Thank you very much for your consideration of our manuscript (nhess-2021-163) for the potential publication and your suggestions about the minor revision. We have revised the manuscript according to the reviewers' suggestions, and proof-read the manuscript to minimize typographical, grammatical, and bibliographical errors. We prepared three documents as requested: (1) a point-to-point reviewer response document including original comments, our response, and corresponding revisions made in the manuscript, (2) a marked-up manuscript version showing all the detailed modifications in the manuscript, and (3) a revised manuscript.

## Responses to Referee #1

# Responses to Referee #2

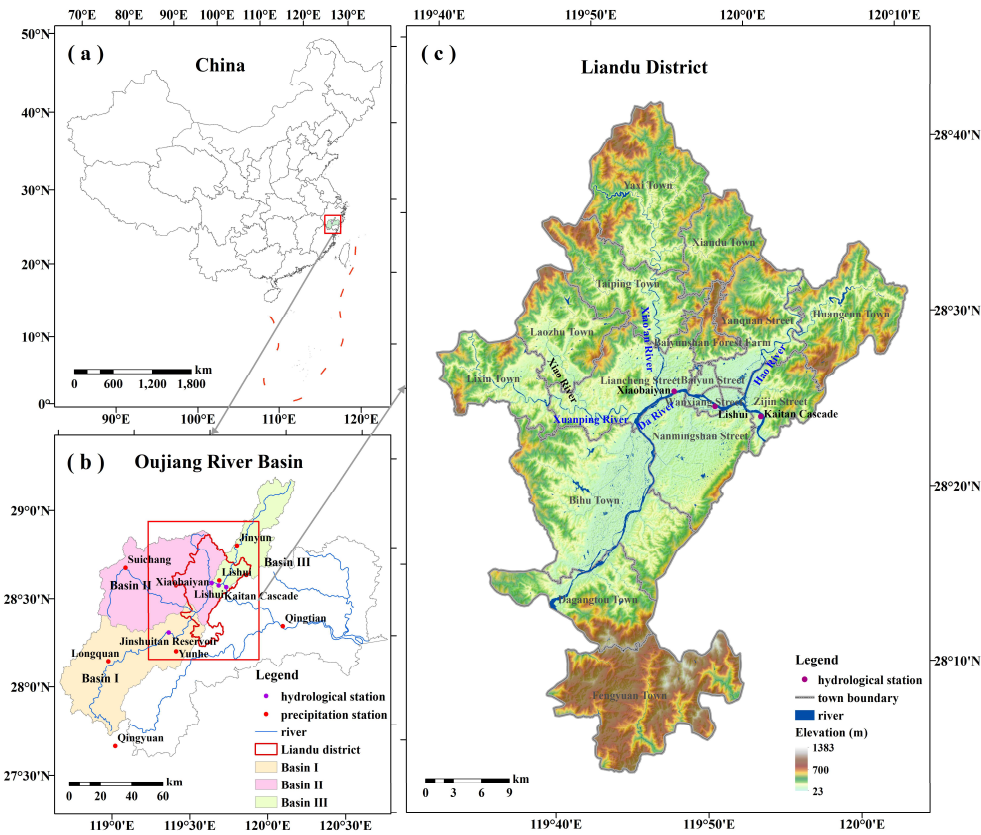
4. Line 70: there is no legend in the light blue area in Figure 1 (b).

**Response:** The light blue area in Figure 1b refers to the Oujiang River Basin. In order to

distinguish it from the sub basin, we set the fill color of the Oujiang River Basin as no color.

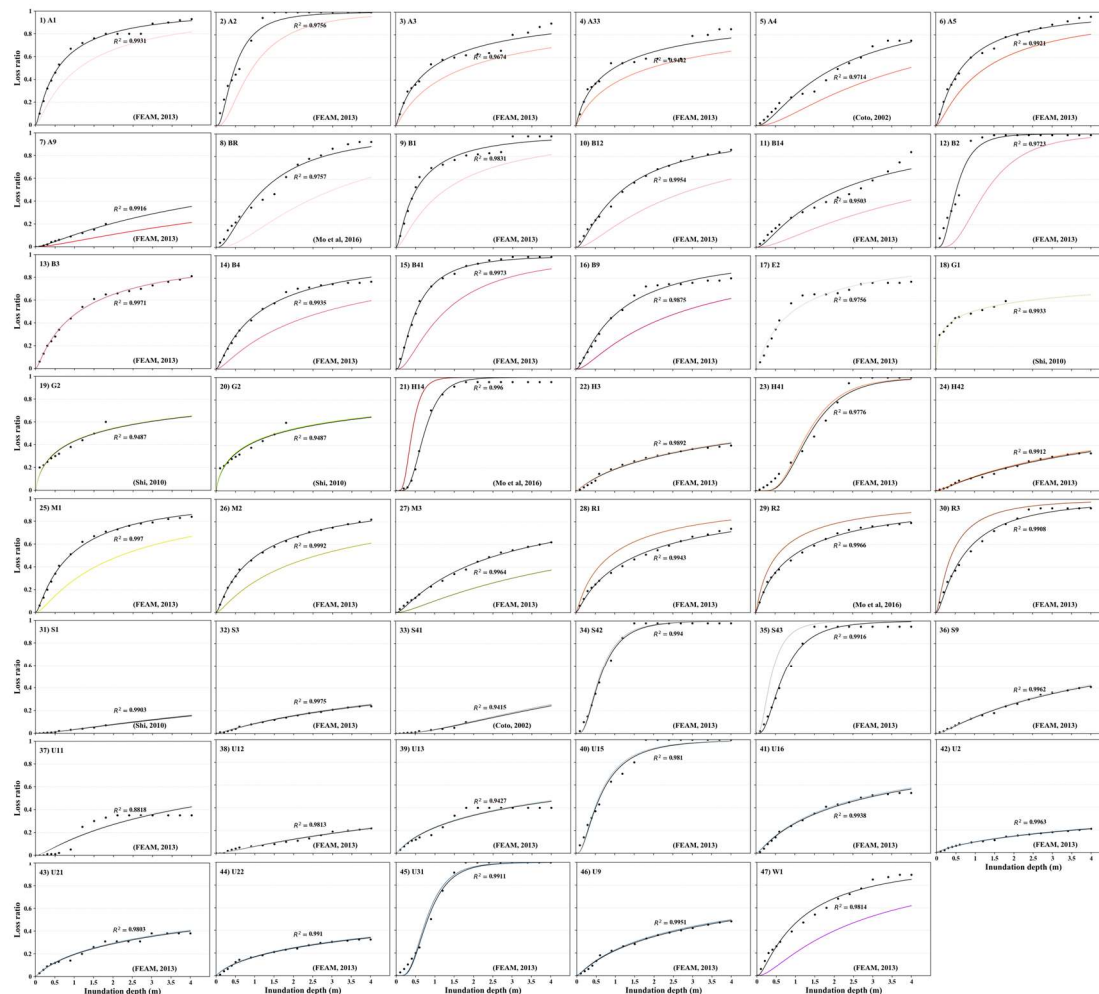
11. Now I see your figure 6, but you have a reference there to FEAM 2013, which I cannot find in your list of references. Also, in the figure caption you write that the color curve is the optimized result, but the graphs seem to indicate the reverse, with the black being the best fit to the data. Am I missing something? Am I correct in interpreting that the black dots in your figures are data points from the references, to which you initially fit you VC, and then you adjust some kind of scale parameter to get a new optimized fit to your own data for the Liandu event? This is somewhat confusing and need to be better explained and clarified.

9. **Line 173-174: please indicate which data source each type of land use refers to. You can quote the Figure 6.**

13. Line 231: it is recommended to specify what the black dots in the Figure 6 refer to. In addition, Figure 6(42) should add the index and title of the horizontal axis.

**Response:** The black dots in Fig.6 refer to the inundation depth and loss ratio constructed according to the corresponding reference. The black curve is obtained by fitting the inundation depth and the loss ratio (black dots) through the lognormal cumulative distribution function, which is the vulnerability curve. Then, based on the disaster loss reporting, the scale parameters of the lognormal cumulative distribution function (black curve) of different land use are optimized to obtain the optimized vulnerability curve (color curve), and the curve uses the same color as the land use type in Fig.5a.

**Line 266-268:** Figure 6. Fitting and optimization of vulnerability curves of landuse in Liandu district (The black dots refer to the inundation depth and loss ratio based on the reference, the black curve is the fitting result of the black dots by the lognormal CDF, and the color curve is the optimized result based on the disaster loss reporting).

**Response:** Thanks for your suggestion, and we have added a quote to Figure 6 at the end of the sentence in the revised manuscript.

**Response:** The black dots in the Figure 6 refer to the inundation depth and loss ratio constructed according to the corresponding reference, and we have added the description in the title of Figure 6. In addition, we have added the tick labels and title of the horizontal axis in Figure 6(42).
